August 28, 2014
NND-14-0471
10 CFR 50.90

Virgil C. Summer Nuclear Station (VCSNS) Units 2 and 3
Combined License Nos. NPF-93 and NPF-94
Docket Nos. 52-027 & 52-028

Subject: LAR 13-23 R2 Reinforced Concrete to Steel Plate Composite Construction Connections

UFSAR Subsection 3H, Figure 3H.5-7 - Revise information as shown in the revised figure on the following pages.

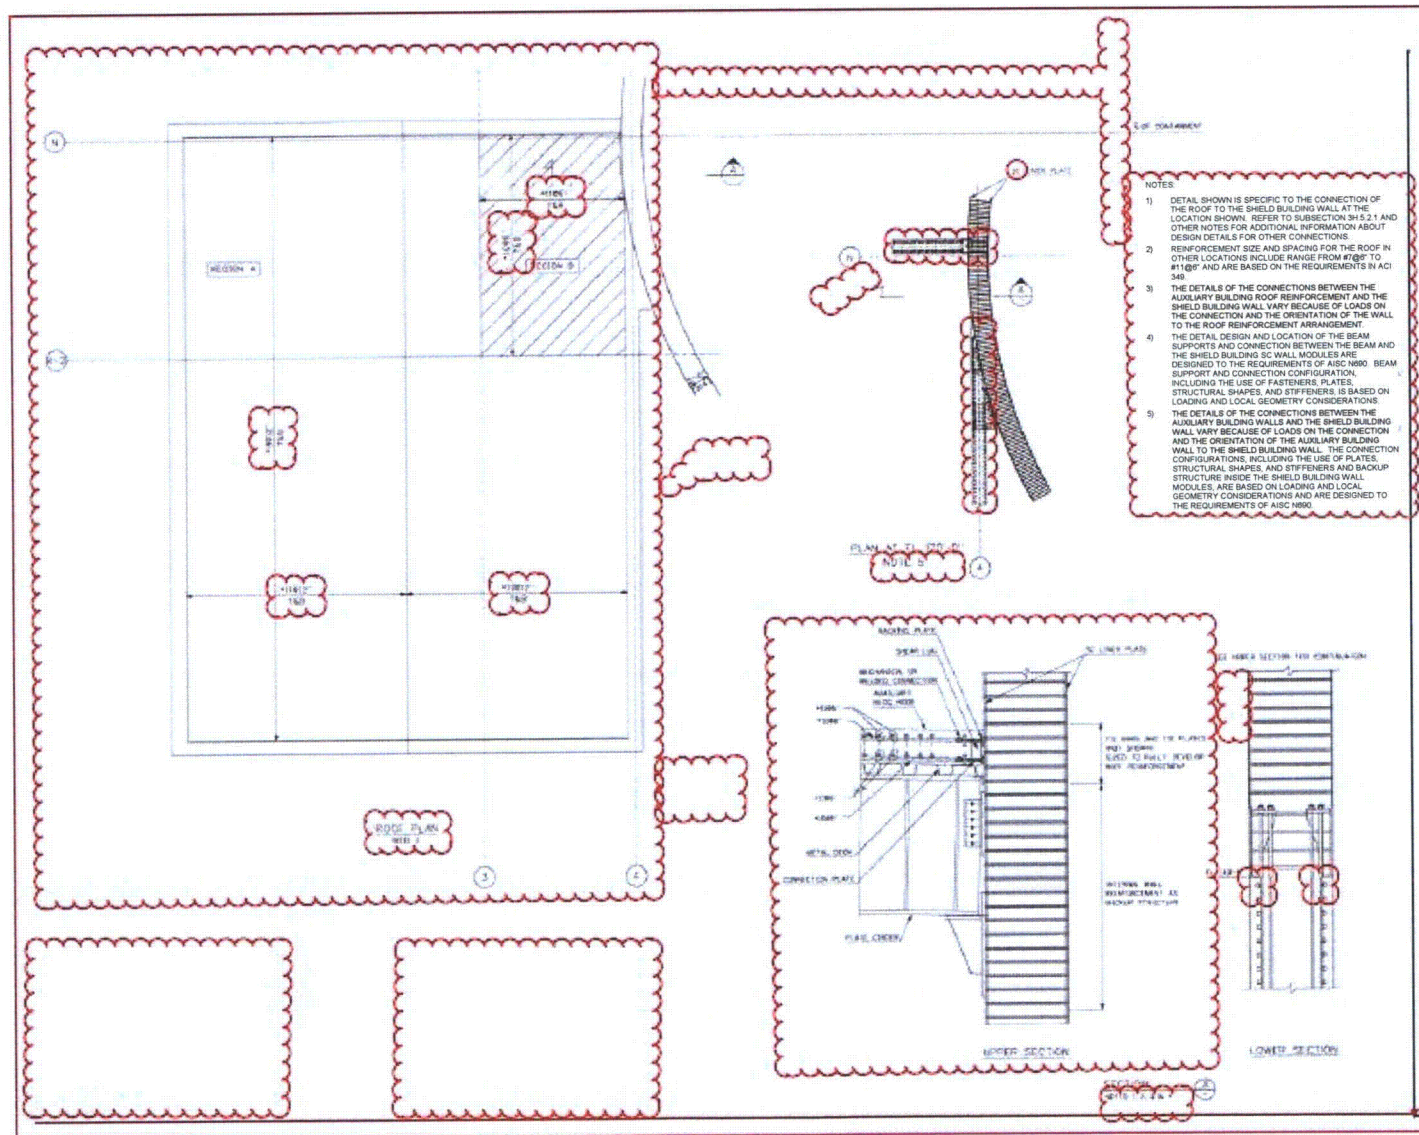
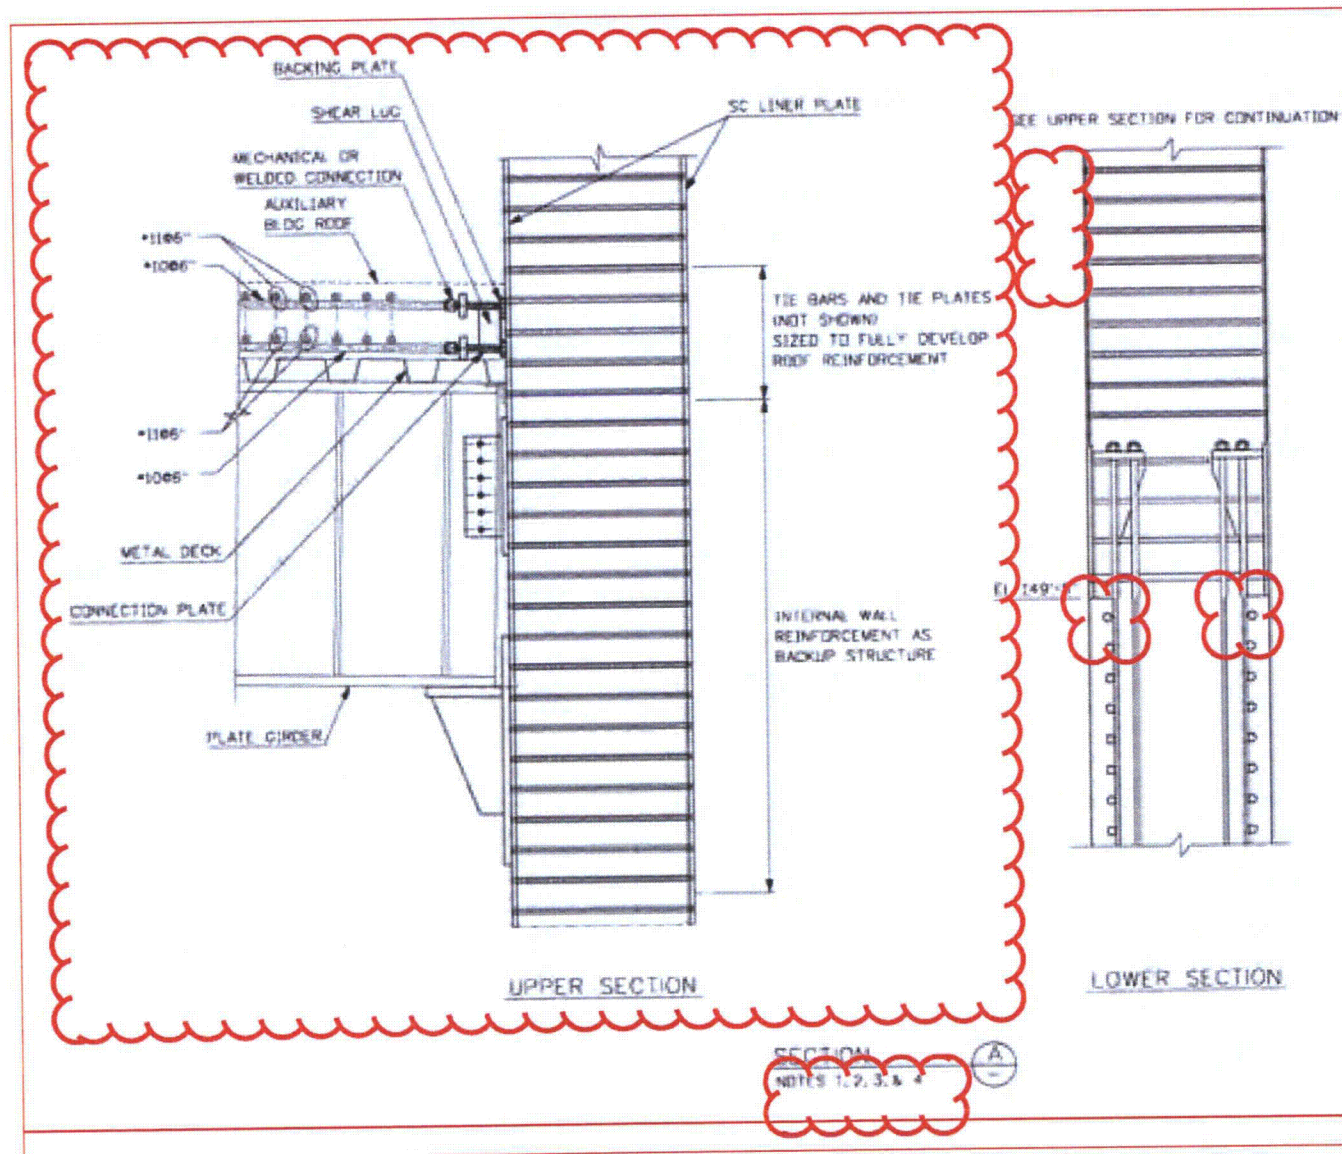
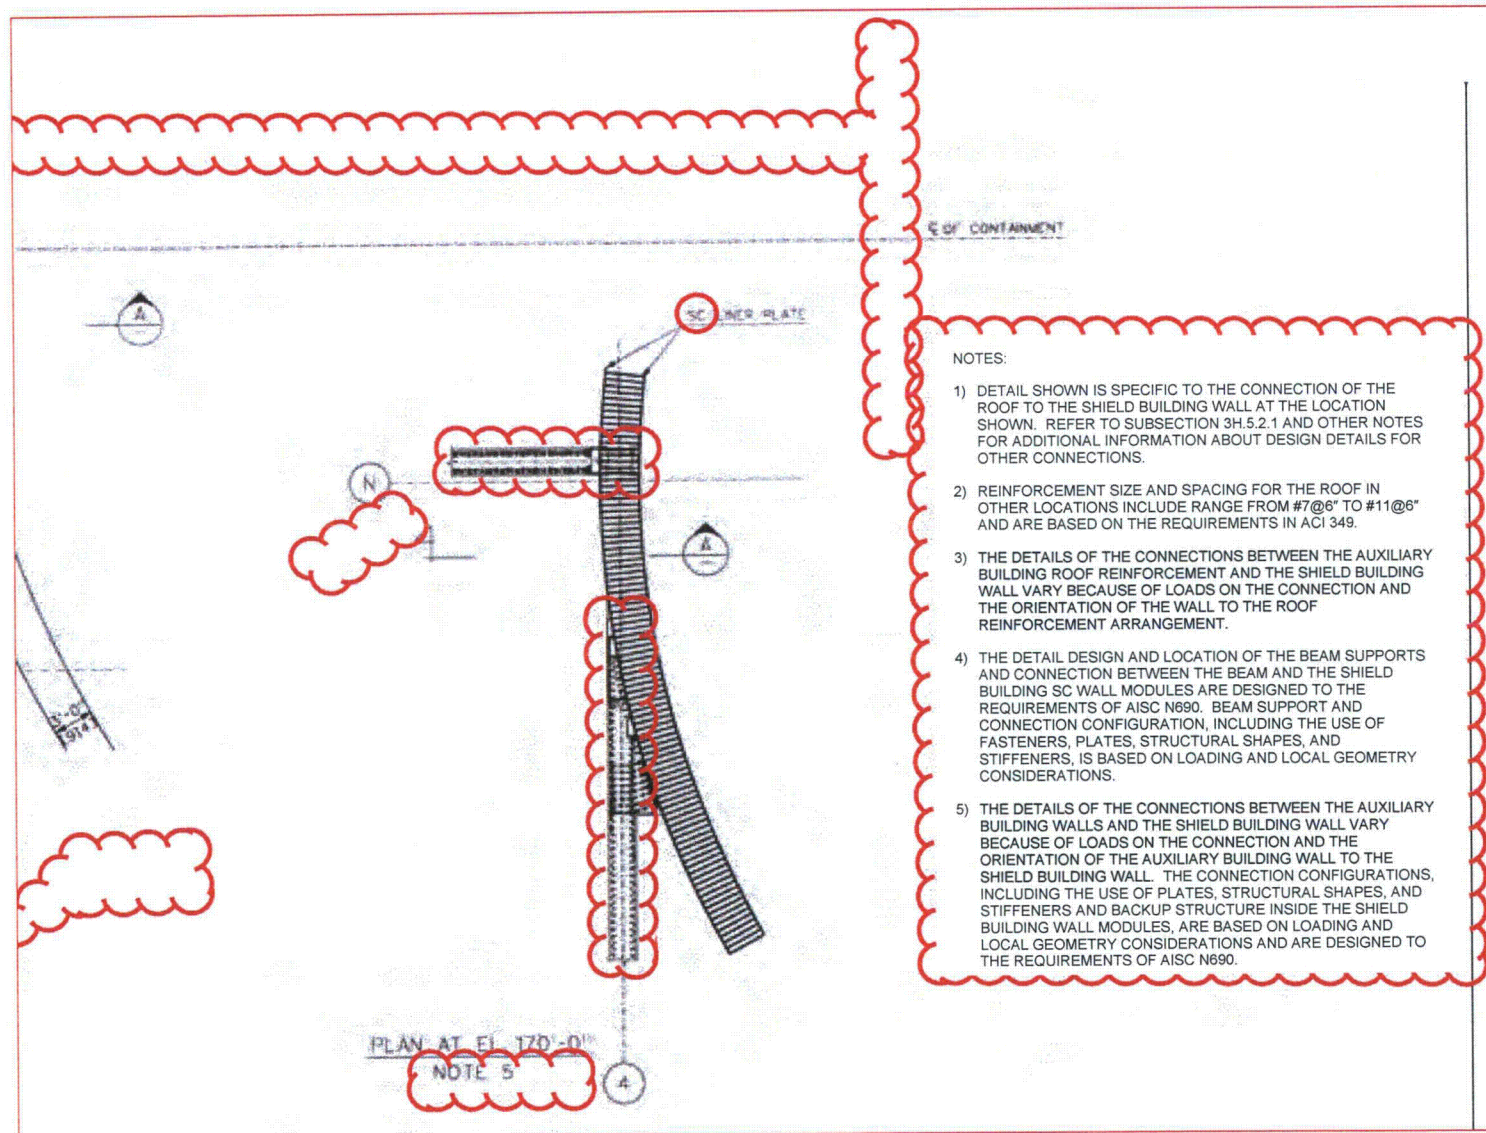
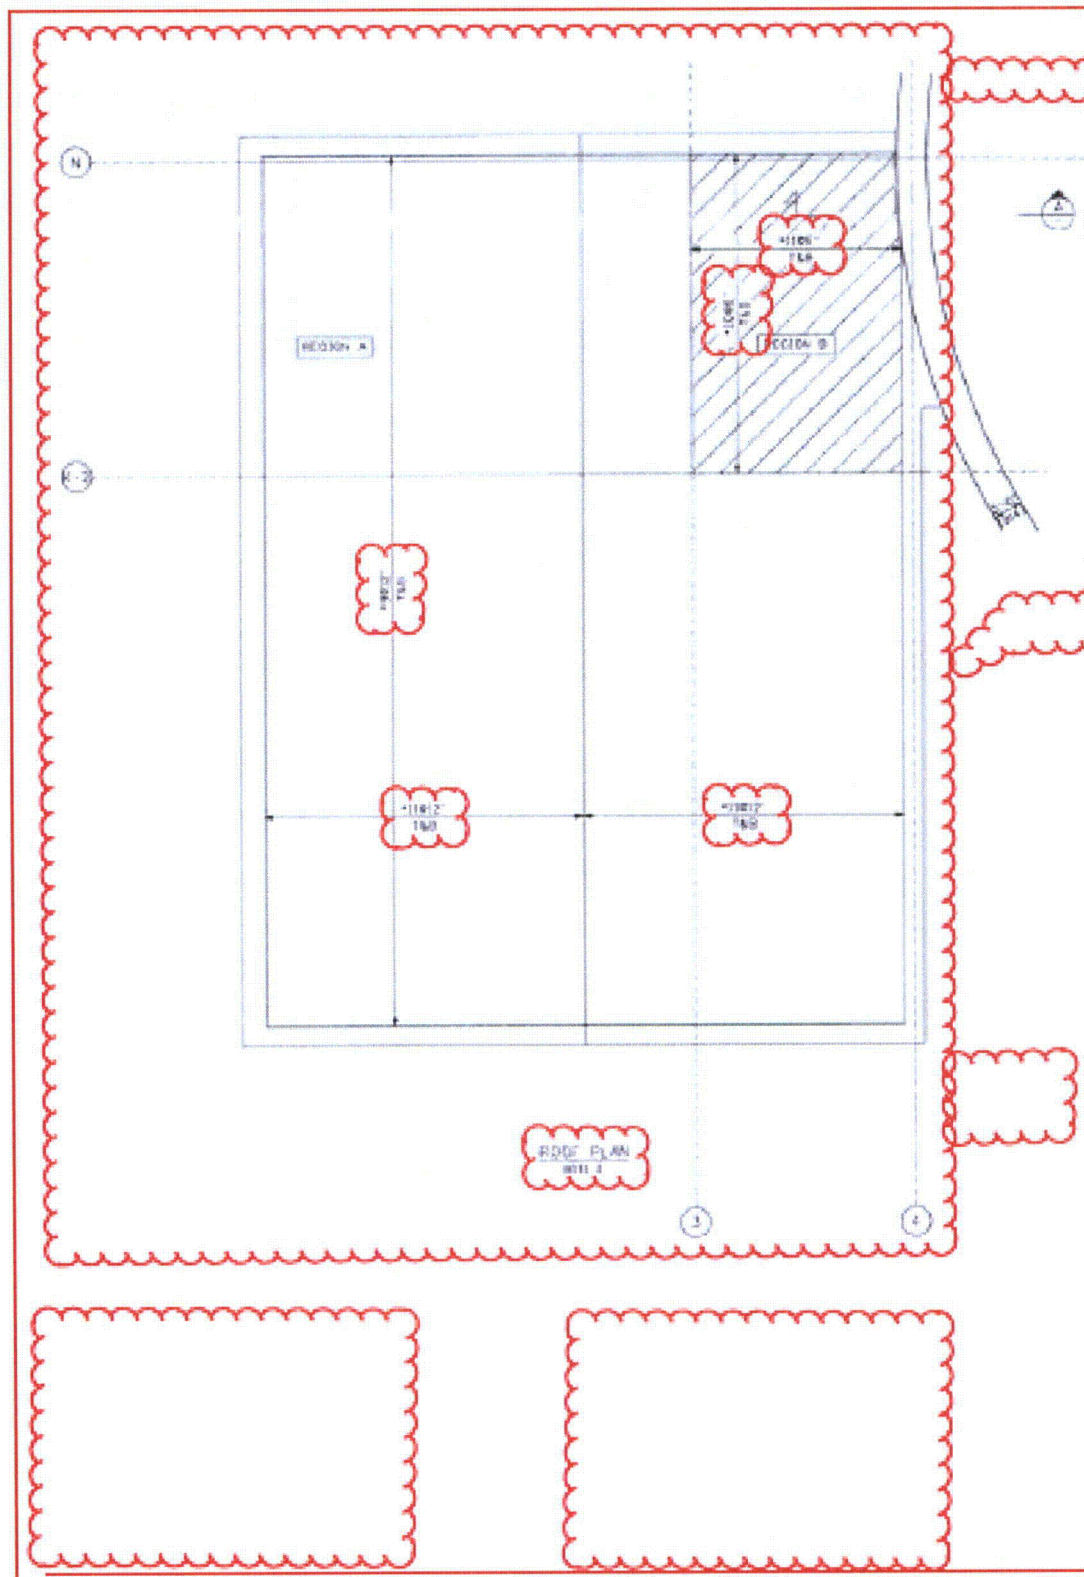
Revise the information in UFSAR Figure 3H.5-7 as follows:

1. The Upper Section in the Section A detail showing an elevation of the roof to wall module connection information is revised to reflect changes to the connection of the roof to the wall including change in the design of the shear lug, addition of a connection plate for connection of roof reinforcement to structural modules, the addition of a stiffener plate, the addition of an connecting plate welded to the module faceplate, and the change in the design of the connection of the girder to the wall. The extension of roof reinforcement into the wall is removed and tie bars in the wall module are designated as internal wall reinforcement to develop roof reinforcement and provide backup structure for the roof girder connection.

2. Extraneous information is removed from the roof plan including the shield building wall radius and thickness, dimensions of the roof and walls, column lines not needed to define the critical section, distance between column lines, roof elevations, and center lines and the information removed from UFSAR Figure 3H.5-7 is provided in UFSAR Figure 3.7.2-12 and Subsection 3H.5.2.2. The representation of the roof reinforcement requirement is changed to not extend into the wall. The N (North) direction indicator is removed from the upper right portion of the figure.

3. The partial PLAN AT EL. 170'-0" which shows the connections between auxiliary building Wall 4 and Wall N and the shield building wall is revised. The information revised is the detail design of the connection of auxiliary building walls to the shield building wall, and these connections are not included in the critical section addressed in UFSAR Subsection 3H.5.2.1 and this figure.

4. The drawing scale is removed from the Roof Plan because UFSAR figures are not to scale. The scale is not relevant to the critical section addressed in UFSAR Subsection 3H.5.2.1 and this figure and UFSAR figures are not to scale.

5. The REINFORCEMENT FLOOR DETAIL IN REGION "A" information is removed since the information is provided in other UFSAR figures including Figure 3H.5-6. The size and spacing of the reinforcement bars are shown in the Roof Plan of Figure 3H.5-7. The dimensions of the metal decking and the roof thickness are included in Figure 3H.5-6.

6. The REINFORCEMENT FLOOR DETAIL IN REGION "B" is removed since it is duplicate information to the Tier 2* information details shown in SECTION A.
7. The tie bar spacing is removed from the Lower Section in Section A. This information is available in APP-GW-GLR-602, Figure 6.

8. Couplers are removed from the vertical bars in the Lower Section of Section A to reflect changes in the detail design.
9. The following notes are added.

- 1) Detail shown is specific to the connection of the roof to the shield building wall at the location shown. Refer to Subsection 3H.5.2.1 and other notes for additional information about design details for other connections.

- 4) The detail design and location of the beam supports and connection between the beam and the shield building SC wall modules are designed to the requirements of AISC N690. Beam support and connection configuration, including the use of fasteners, plates, structural shapes, and stiffeners, is based on loading and local geometry considerations.

**Figure 7, Typical Auxiliary building RC roof connection to the shield building SC wall -
Revise the figure as shown below.**

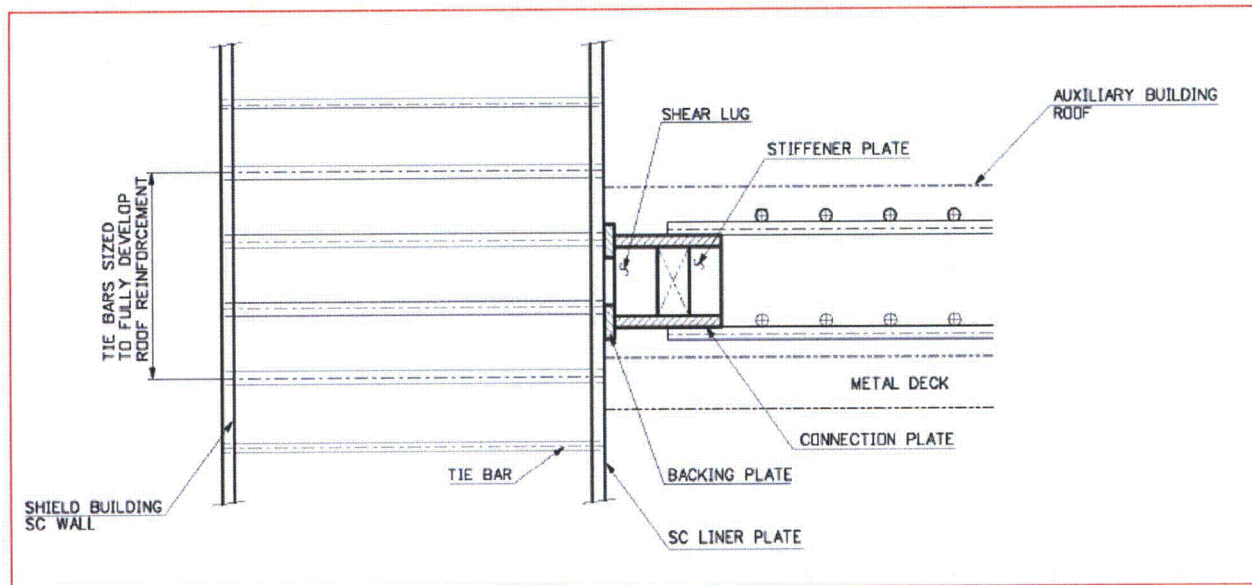
Revise Figure 7 to show a revised connection design including:

7. Revise Note 1 to remove the specific size and spacing of reinforcement inside the wall and add the requirement to fully develop reinforcement in the roof.

8. Revise Note 2 to include discussion of load path through connection plates and tie bars.
9. Revise Note 2 to identify that the details of the connection design may vary.

10. Remove Note 5 and move information on couplers to Subsection 3.8.4.5.5.6.
11. Add note to reference Subsection 3.8.4.5.5.6 for supplemental design requirements.

**Figure 7, Typical Auxiliary building RC roof connection to the shield building SC wall -
Revise the notes to include revised information in the locations shown below.**

1. The connection inside the shield building wall is provided by through wall tie bars sized to fully develop the Auxiliary Building Roof a range of reinforcement. ~~[~~
 ~~]^{a,6} Spacing is determined along the shield building wall.~~
